MEMORANDUM

To: T.C. Greengard
From: B.P. Doty
Date: July 21, 1988

Subject: DOE Comments on 881 Hillside RI/FS

Figure 2. Bis(2-ethylhexyl)phthalate Profiles at SWMU 119.1

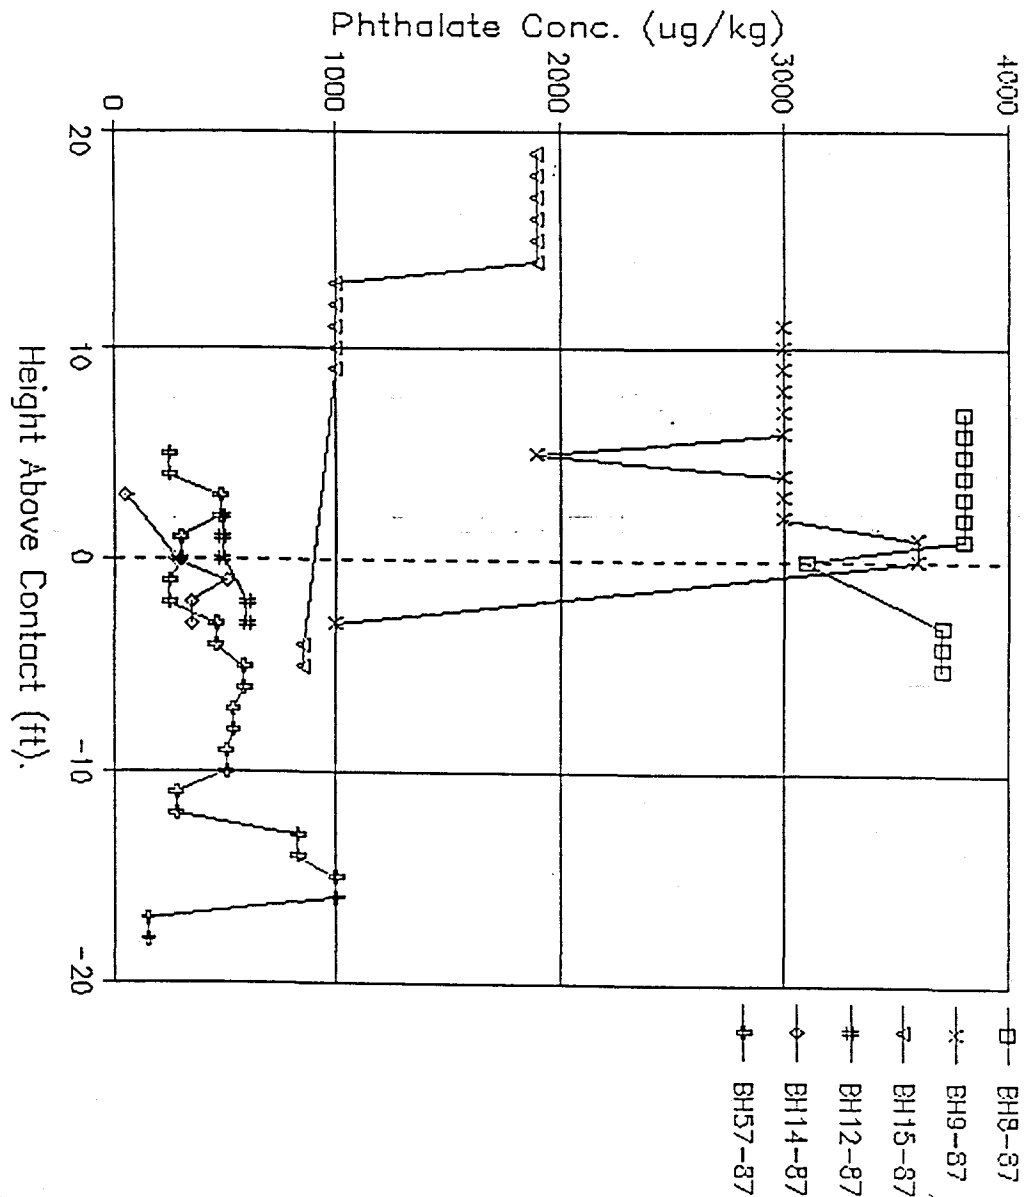
Soil gas detection at the northern perimeter of the 881 Hillside area and soil contamination (primarily bis(2-ethylhexyl)phthalate) at boreholes topographically and hydraulically up-gradient of SWMU 119.1 (boreholes BH9-87, BH15-87, and BH8-87) suggest contamination from source(s) above the hillside and just west of the stock piles. The RI should discuss the source of this possible contamination and consider extending boreholes and/or soil gas samples northward.

Bis(2-ethylhexyl)phthalate concentrations are definitely elevated up-hill from SWMU 119.1 as compared to samples

obtained from within the SWMU area. This is shown in Table 3 and diagrammatically on Figure 2. It is hypothesized that the bis(2-ethylhexyl)phthalate concentrations in excess of about 1,000 ug/kg are significant concentrations and that the lower concentrations (all within the SWMU itself) may be residual levels after extraction by waste solvents. The concentrations uphill probably result from drum storage; the SWMU should probably be extended to include these areas.

It is the opinion of the FS team that additional investigation of uphill areas is not warranted, given the nature of the recommended remedial action. Because the french drain will capture all colluvial ground-water flow, the exact locations of sources is not critical to the performance of the system.

Figure 3. 59-86BR SANDSTONE IN CROSS SECTION

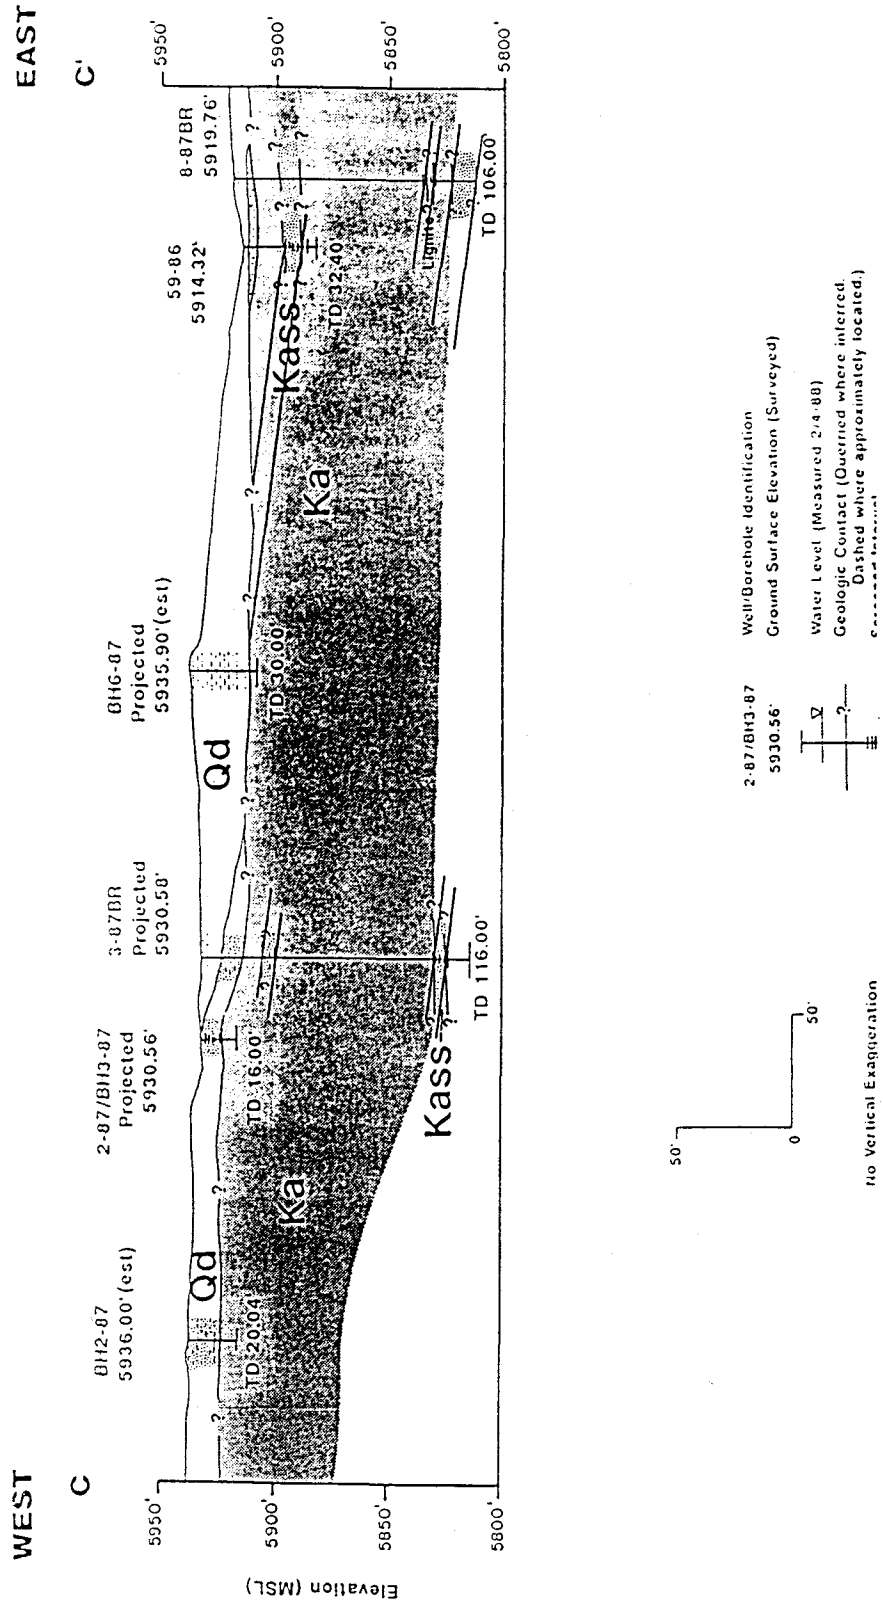
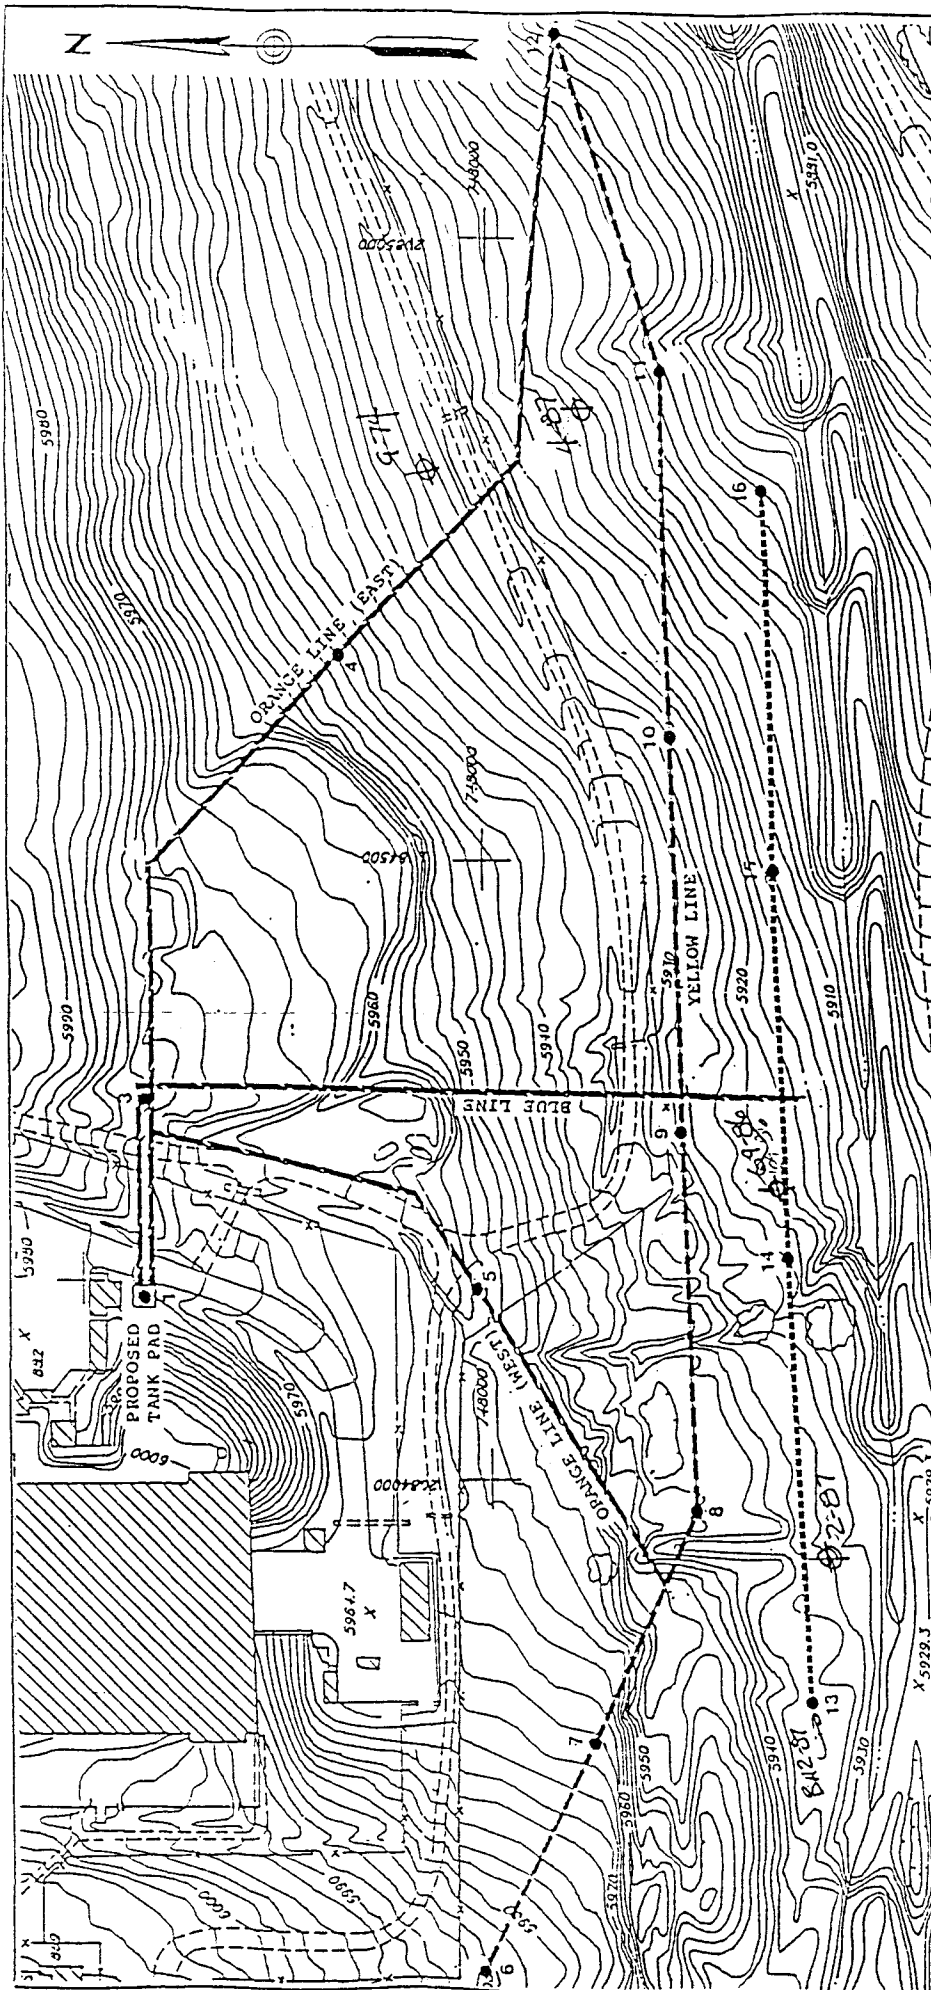
A primary concern with the work done to date at the 881 Hillside is the degree to which the potential for bedrock contamination, both current and future, has been evaluated. The discussion in Section 5.4.3.1 indicates elevated uranium in the uppermost bedrock aquifer at 59-86BR as well as similar groundwater chemistry and selenium concentration to the overlying alluvial groundwater. Considering the proposal to leave waste in place and treat alluvial groundwater, a subcropping sandstone aquifer in the vicinity of Building 881 has a potential for bedrock contamination during the operational life of the treatment facility. Consideration should be given to placing one or two shallow bedrock aquifer wells down-gradient and slightly east of the three well cluster to indicate if suspected bedrock contamination persists down-gradient and down-dip. Also a concentrated geophysical survey combined with a limited number of boreholes in the area bounded by boreholes 59-86BR, BH63-87, BH53-87 and BH3-87 could be implemented to specify the suspected area of bedrock/alluvium communication.

Nonetheless, the RI team shares the concern expressed by the reviewer with regard the evaluation of bedrock contamination. Detailed discussions together with supporting data are presented in the RI dealing with the evaluation of chemical conditions in the bedrock. The essence of the discussions is presented in Table 4 and can be summarized as follows.

1. At SWMU 119.1, bedrock ground water is distinctly different from colluvial ground water (based on major ion, uranium and organic differences); therefore, colluvial ground water is in poor connection with bedrock ground water and there is little potential for impact to the bedrock ground water.

2. At SWMUs 103, 106 and 107 (south of Building 881), deeper bedrock ground water is distinctly different from colluvial and shallowest bedrock ground water (based primarily on uranium differences); however, shallowest bedrock ground water cannot be differentiated from colluvial ground water and the two systems appear to be well connected based on chemical similarities. The effects of lithologic variations are discussed under Specific Comment 6 in this document.

3. Although the colluvial and shallowest bedrock ground waters appear connected at the three well cluster, neither of these waters is contaminated. Uranium is the only constituent that could be considered a contaminant, and it is not considered to be a problem because the concentrations are low

Figure 1. BORING & WELL LOCATIONS AND PCE SOIL GAS RESULTS

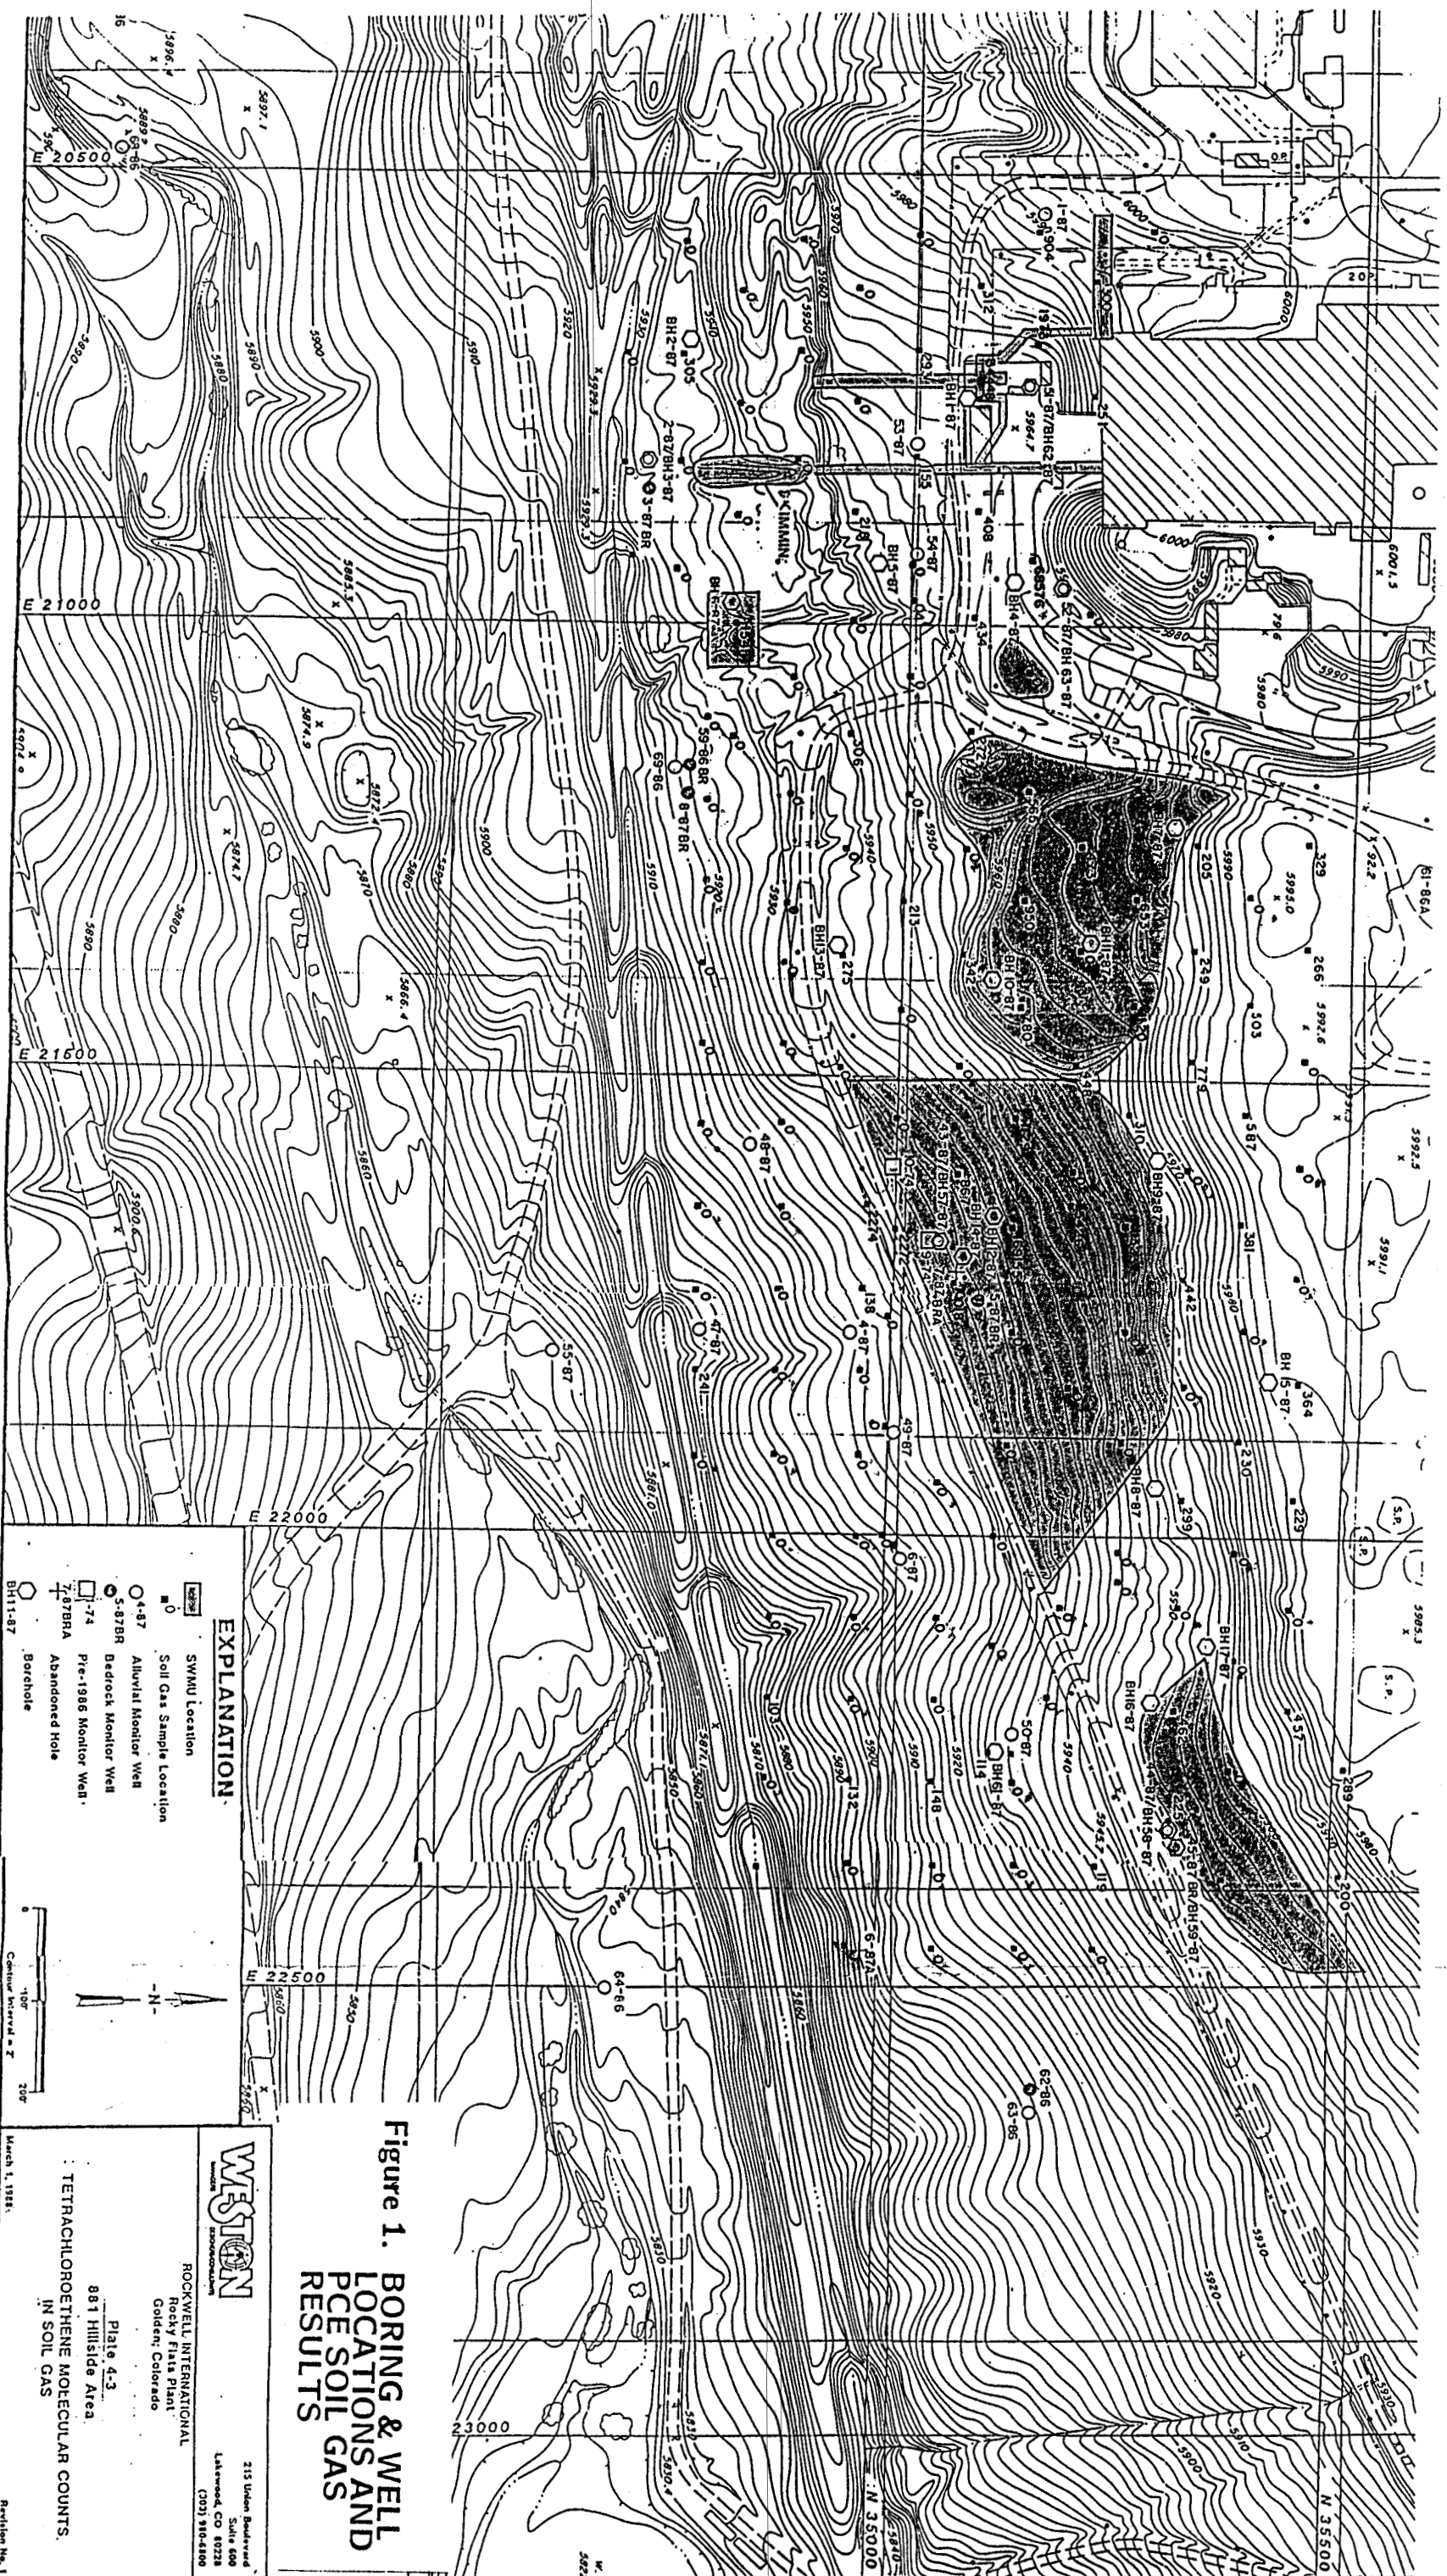
Volatile organic compound (VOC) soil gas detection is not always supported by borehole sampling and vice versa. Examples are at SWMU 102 where PCE is detected at soil gas point 106 but not in a borehole 25' away and at SWMU 103 where a detected PCE count of over 68,000 is not supported with nearby borehole detection. There are also numerous instances of high soil gas detection surrounded by grid points with zero detection. The data suggest that either the VOC contaminated areas are isolated spills confined in discontinuous high porosity beds or that detection at the level necessary to define low-level plume fringes is not possible (see comments 14 and 15). While the first case is

PCE was found at 1,541 counts at soil gas point 106 (Figure 1). Given that the range averages about 45% of the value, the true count could be anywhere from about 850 to 2,200, i.e., the true count could be below the reliability limit of 1,000 counts. Borehole BH6-87 was drilled as close as possible to the soil gas point (approximately 25 feet away) to investigate the apparently significant soil gas count. PCE was not detected in the soil. Methylene chloride was found in the samples at relatively low and probably environmentally insignificant concentrations. It is concluded that the soil gas count at point 106 is due to vapor phase transport of volatiles from some other source (probably uphill) and does not indicate a significant source in the immediate vicinity.

Thus, it is concluded that PCE is probably present in either the ground water or soils at the location of soil gas point 88 (count is definitely significant), but that significant volatile organic contamination is not present either uphill (BH63-87/well 52-87) or to the south in the utility trench (BH4-87). The RI/FS team was not completely satisfied with the characterization in this area and, as a consequence, recommended a very conservative remedial action (the french drain).

The comment mentions numerous instances of high soil gas detection surrounded by grid points with zero detection. With the exception of the 1,541 counts at point 106, the PCE data do not appear to support this portion of the comment. Based on discussions above, ion counts less than 1,000 are probably not environmentally significant.
